Principal issues discussed at our meeting

RE: DEVELOPMENT OF THE WATER HOUSE AT MILLFIELD LANE, HIGHGATE, N6 6JD

Project No	Project:
633	The Water House

Project no. / Stage / Drawing no.	Date:	Revision:
633(PL)004	JAN.11	C

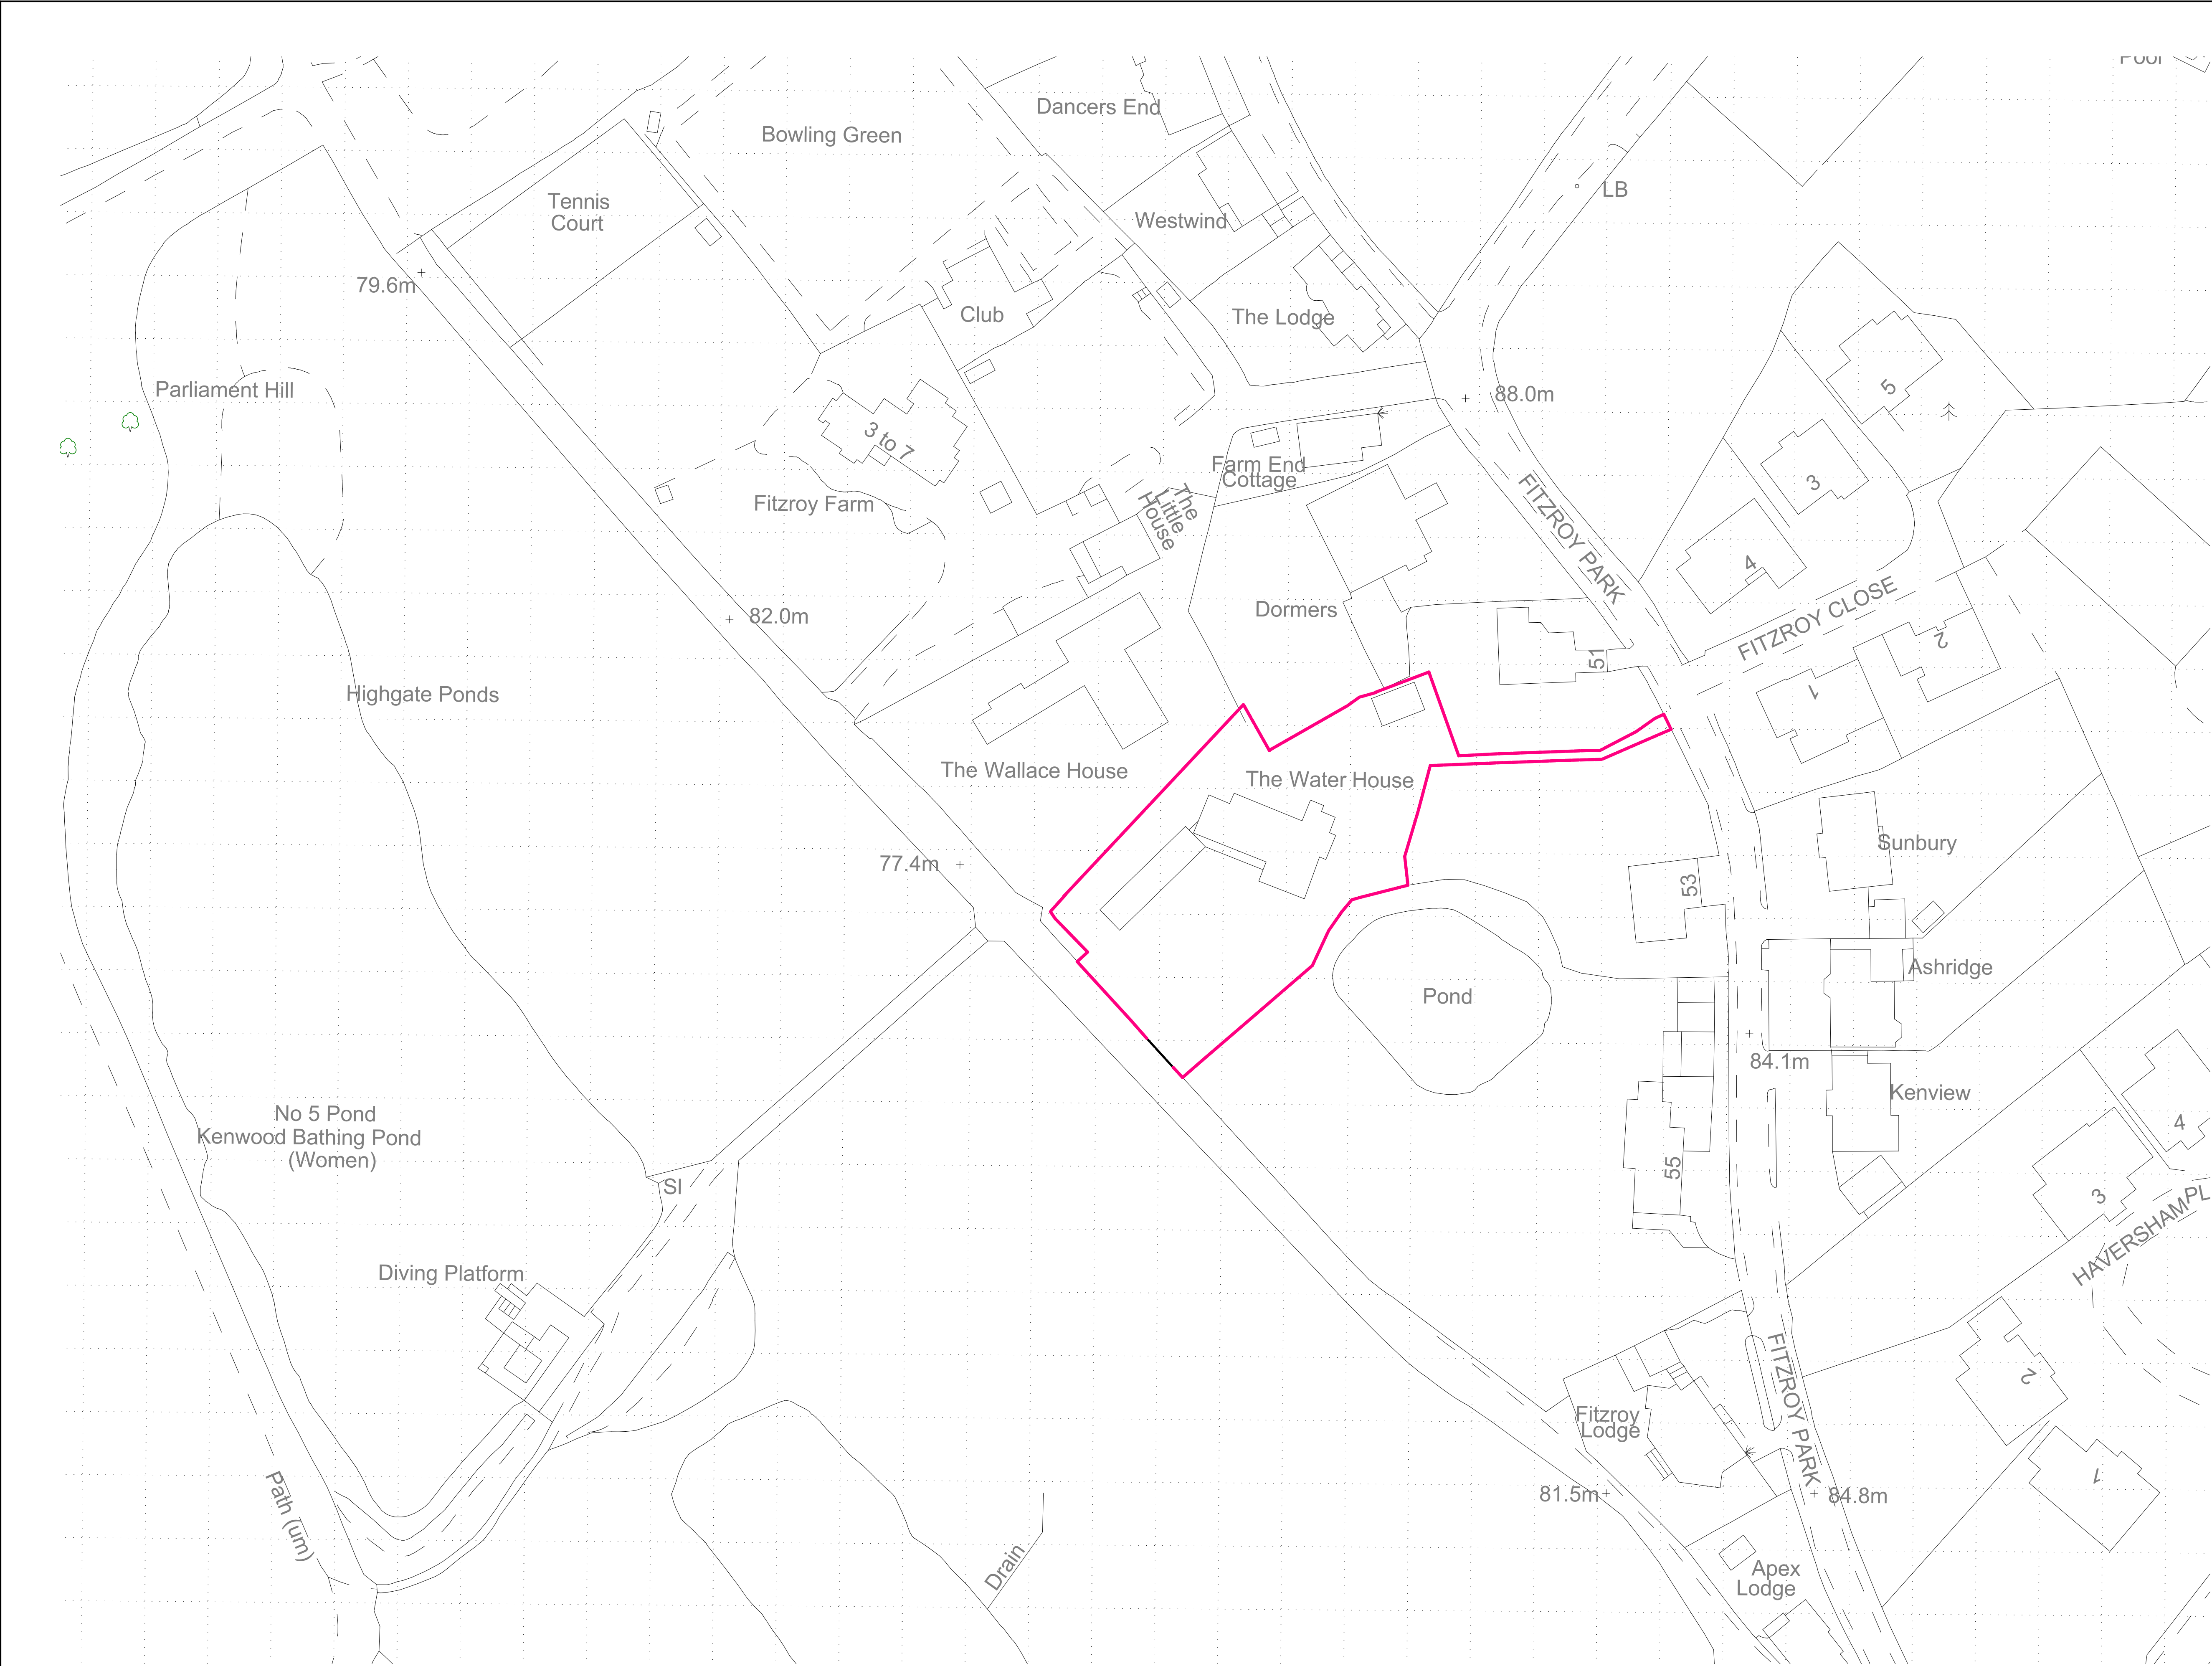
In consideration to the two tests mentioned above; given the design of the proposal, the topography of the site and indeed the distances between neighbouring properties, it is unlikely that if analysed; the proposed development will have any material affect upon the availability of skylight to the windows of either; The Wallace House, Dormers, or 51/53 Fitzroy Park and indeed we would expect them to meet the VSC criteria following the construction of said development.

Furthermore it would appear that sufficient light would continue to pass over the top of the proposed development and thereby maintain a reasonable distribution of light throughout the rooms to all the neighbouring properties.

In summary, it would not appear as though this development will have any material affect upon the daylight to any of the surrounding residential properties.
